TO: PCS Group Inc., Applicant
FROM: Julia Duncan, Associate Planner
DATE: January 24, 2022
SUBJECT: SUB21-073; Compark Village South Tract G Sketch Plan
SUB21-074; Compark Village South Tract G Preliminary Plan
Review Comments 01

COMPARK VILLAGE SOUTH SKETCH PLAN

Compark Village South
Tract A Preliminary
Plan

COMPARK VILLAGE SOUTH
LANDSCAPE PLANS AND
MASTER STREET TREE PLANS

Sheet Name
SITE ENLARGEMENT
Sheet Number

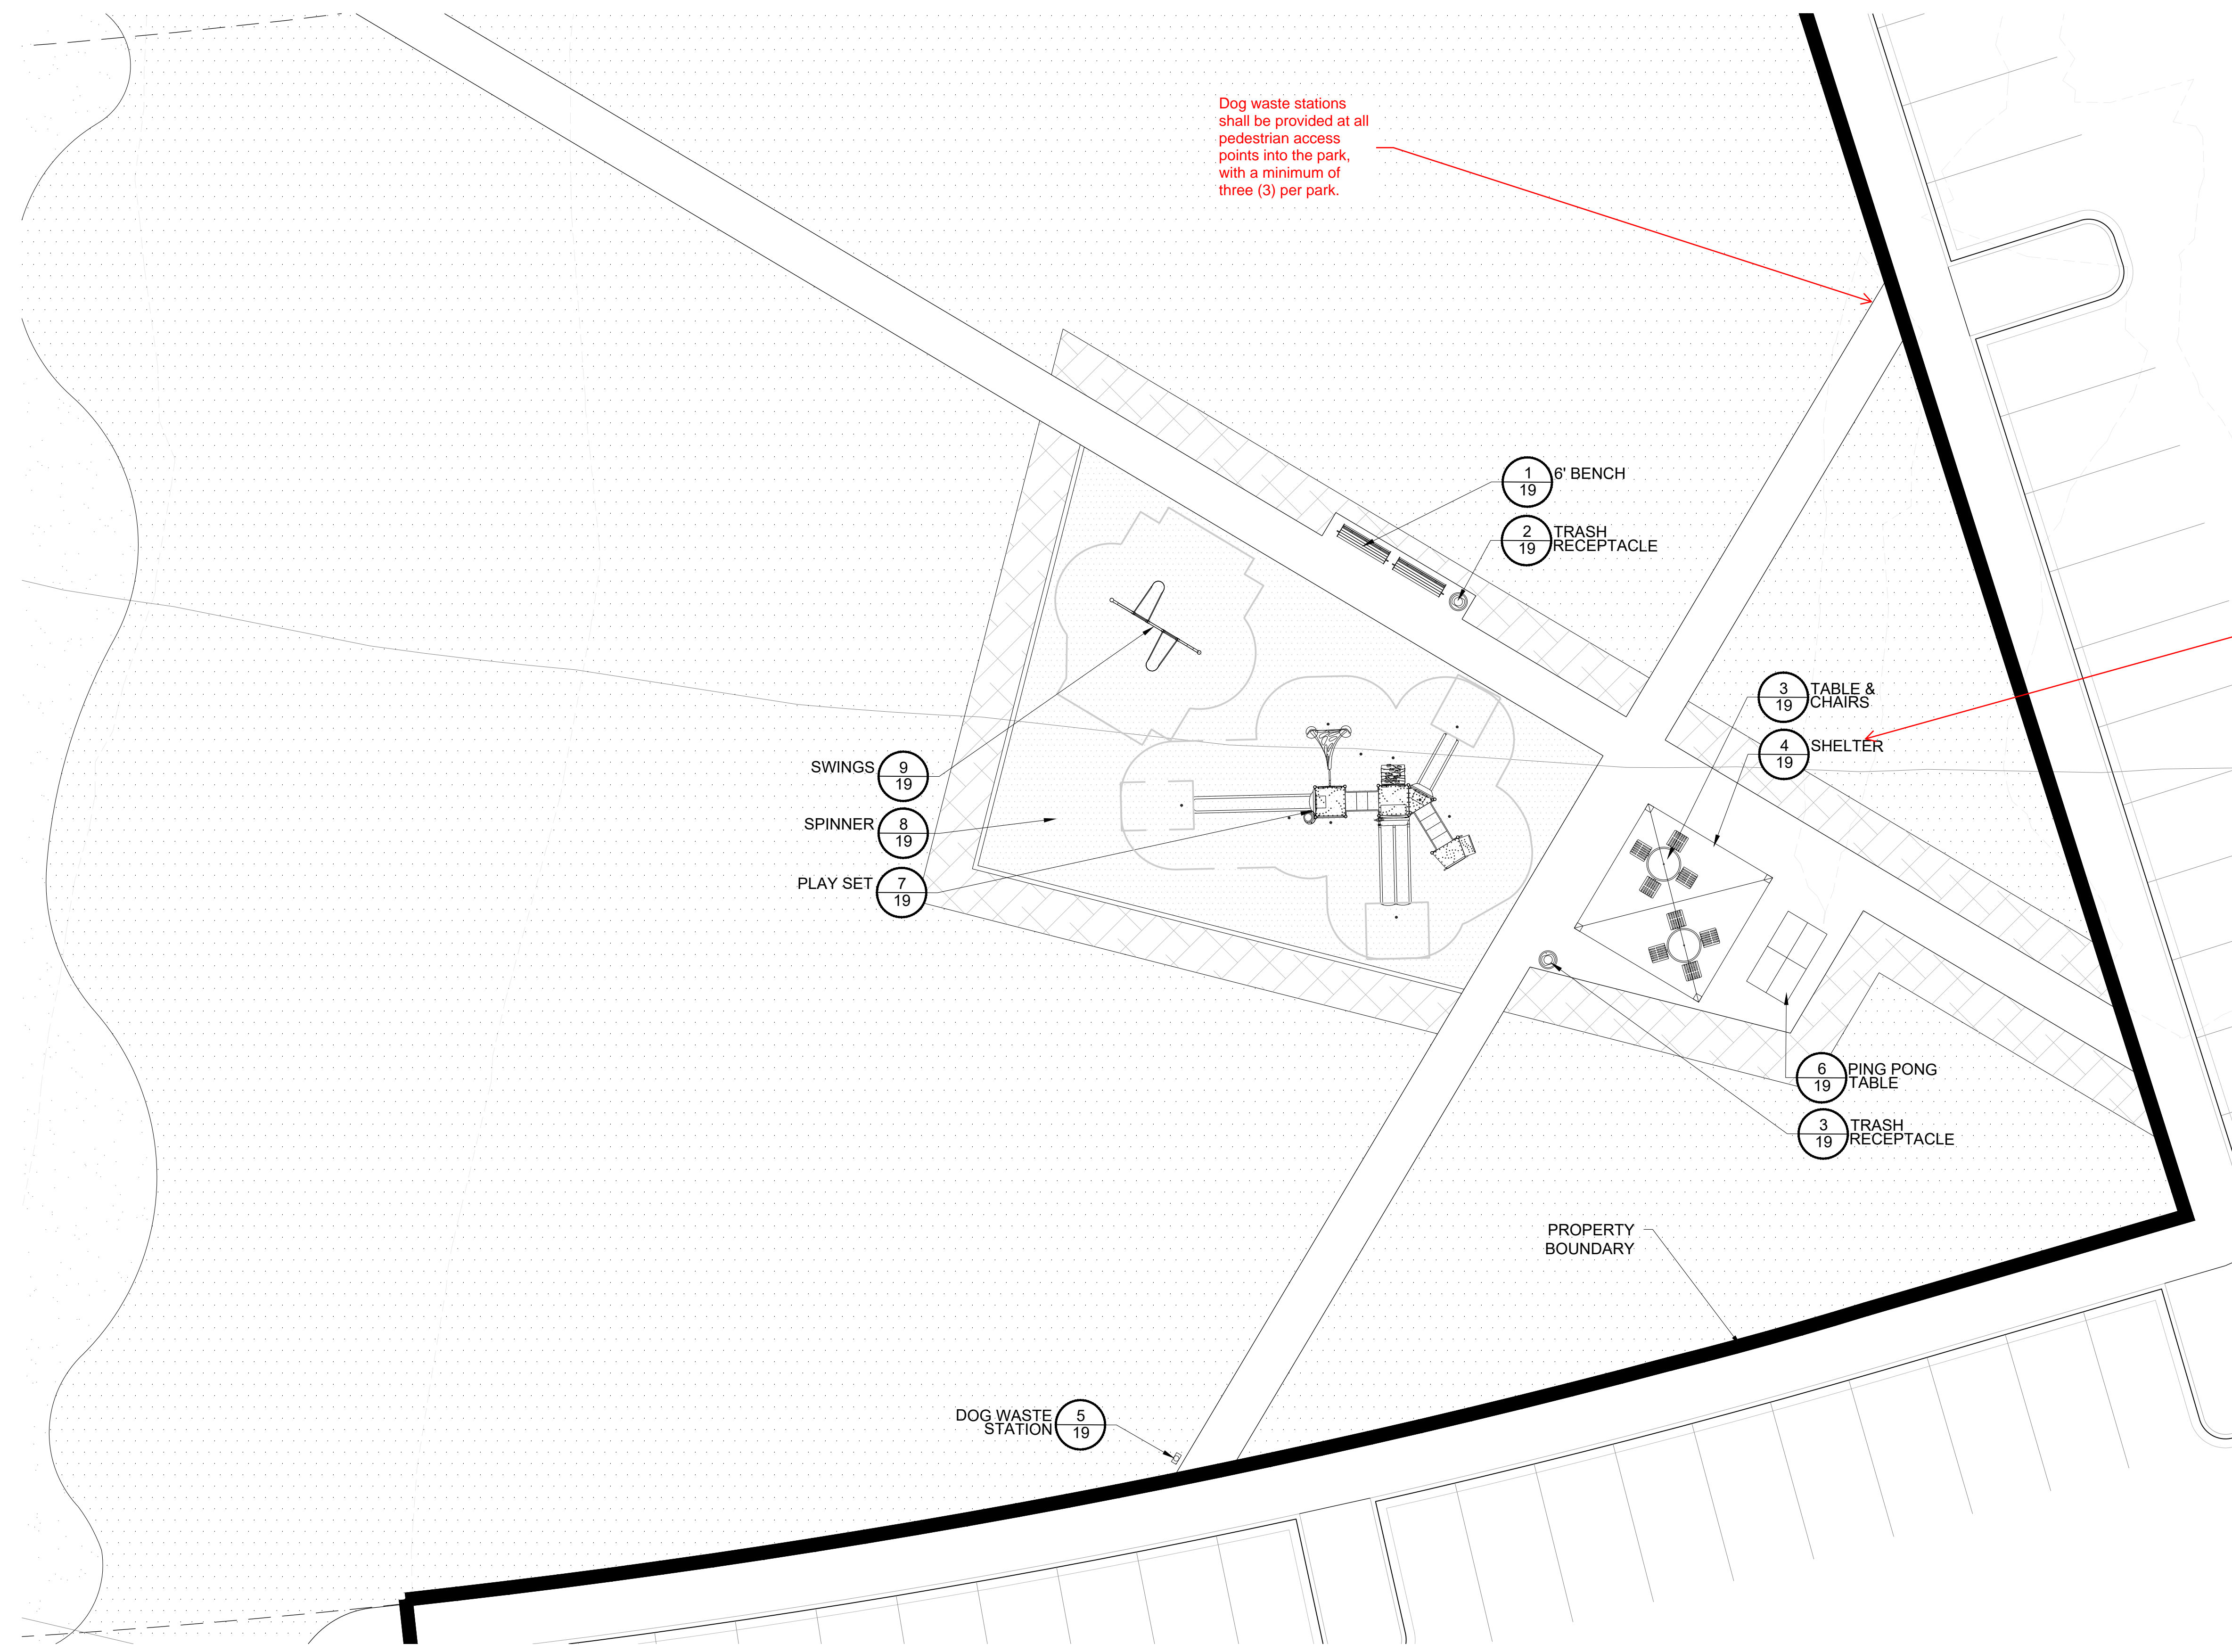
Dog waste stations shall be provided at all pedestrian access points into the park, with a minimum of three (3) per park.

What is shelter capacity

Include an additional chart showing how many of each amenity is provided and how the additional amenities meet your park points requirements from 13.07.140A
